**Subject:** MHI's Responses to US-APWR DCD RAI No. 211-1946

Response to Request for Additional Information No. 211-1946,  
Revision 1

**US-APWR Design Certification  
Mitsubishi Heavy Industries  
Docket No. 52-021**

**RAI NO.:** NO. 211-1946 REVISION 1  
**SRP SECTION:** 03.07.01 – Seismic Design Parameters  
**APPLICATION SECTION:** 3.7.1  
**DATE OF RAI ISSUE:** 02/25/09

**Figure 1.** Three-component accelerograms of the DCD synthesized time history (top) and the Nahanni STN3 modified seeded time history (bottom).

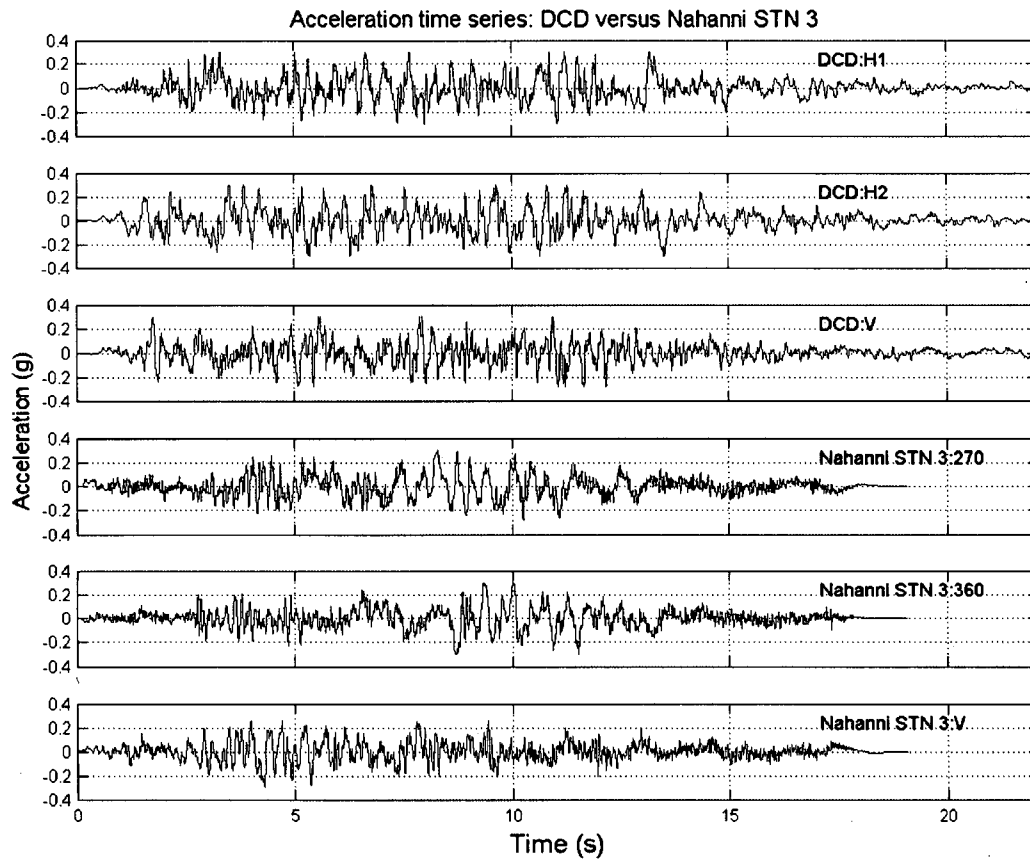
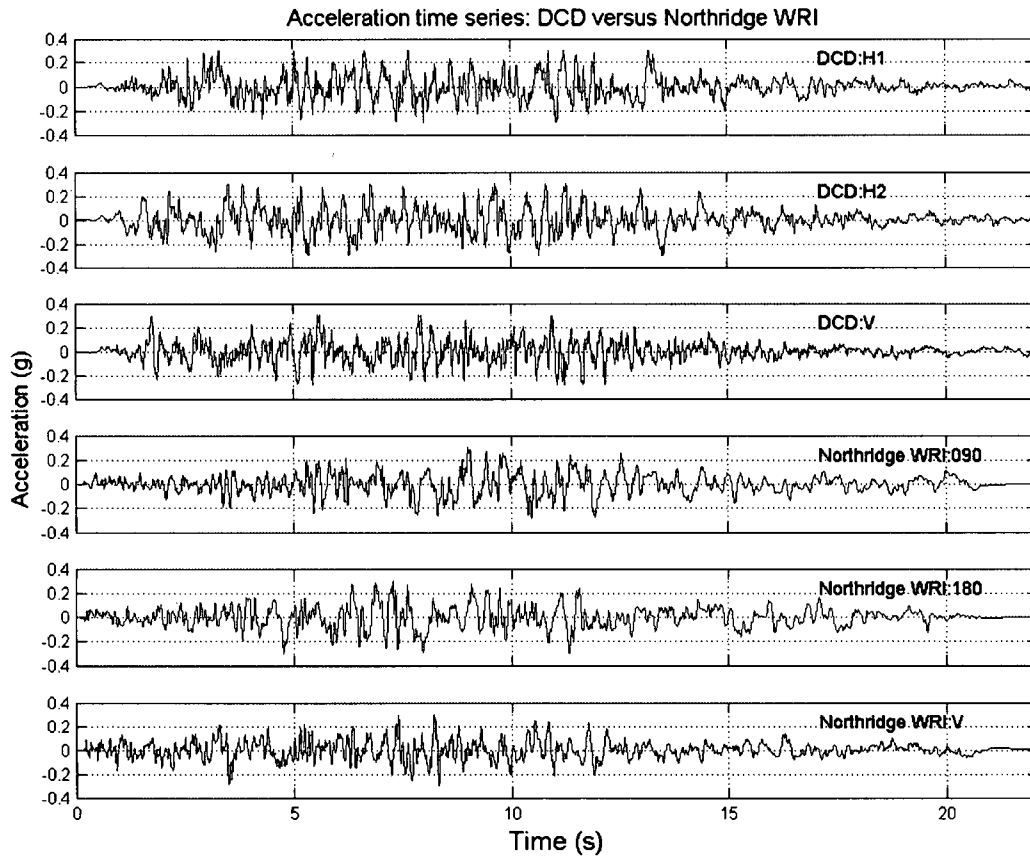
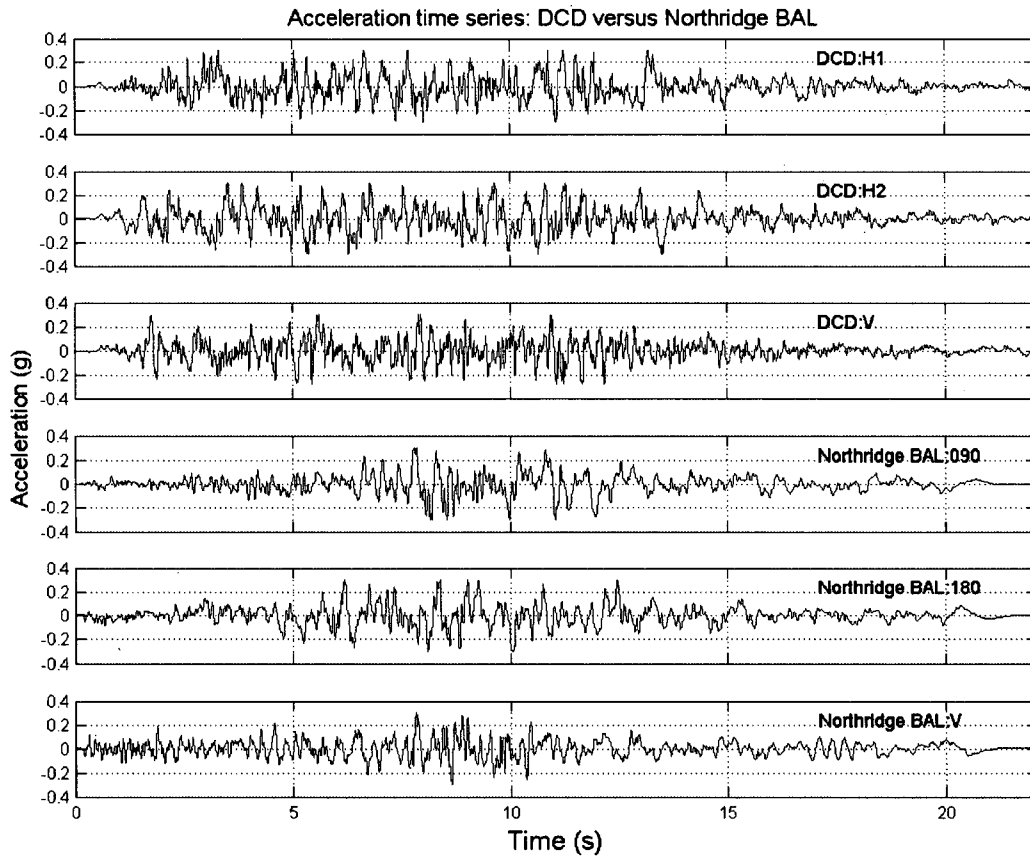
Section 3.7.1.1 of the DCD includes a description of the generation of the artificial ground motion time histories for use as the input motion for the US-APWR standard plant. It is not clear if the artificial ground motion time histories were generated based on seed recorded time histories. The acceptance criteria of the SRP subsection 3.7.1.II.1B states that the artificial ground motion time histories that are not based on seed recorded time histories should not be used. Confirm that the artificial time histories are generated based on seed recorded time histories. Provide justification if the artificial ground motion time histories are not generated based on seed recorded time histories. Also, describe the seed motions used and how they were modified to generate the artificial time histories.

The three-component accelerograms of the synthesized time histories are compared with those of each of the modified seeded time histories in Figures 1, 2, and 3. The overall characteristics of the four histories are similar. In particular, the amplitude of the accelerograms is time varying (non-stationary) and the character of this variation is similar in each set of records. For example, the amplitudes are relatively small initially and then increase to the strong shaking portion as the time progresses. The shaking levels then gradually decrease toward the end of the records.

Figure 1 Comparison of Load- Distortion Angle Relationship between Calculation and Test

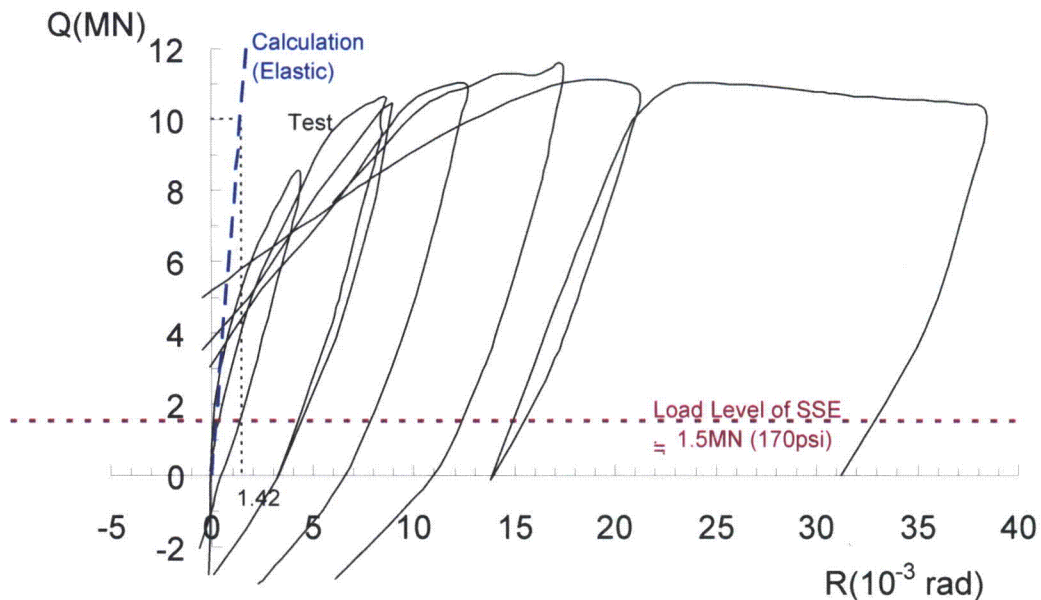
Also, the primary shield wall and other walls inside containment are fabricated as steel-concrete (SC) module walls described in Section 3.8.3.1.5 of the DCD. Discuss the methodology for calculating the stiffness and damping values used in modeling the module walls for seismic analysis of the containment structures. Provide justification including test data to demonstrate the appropriateness of the stiffness and damping values used in the seismic analysis and design.

The above stiffnesses based on elastic properties and composite behavior of steel and concrete are acceptable and have been verified by many test results. See DCD Reference 3.8-27, which shows the 1/10<sup>th</sup> scale model test results of a CIS in a PWR which used SC modular walls to provide validation of the above evaluation method. This reference provides test results that show the equivalent viscous damping of the SC modules at design load level (SSE) of 5 percent. This generally remained constant up to the load level at which the SC module steel plates started yielding. Therefore, it is reasonable to use 4 percent damping for the OBE based on these test results.

Figure 1 below shows a comparison of the deformation between test and calculation (Table 1 below) results based on the above evaluation method. The calculated stiffness corresponds to that of test results near the load level of the SSE.
